# Shearwater Teric and Tern Firmware Release Notes

## VERSION 29 2024-02-29

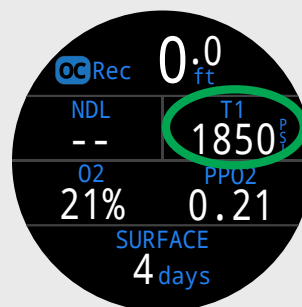
**NEW** Lower frequency option added for beeper, which may be easier for some users to hear.
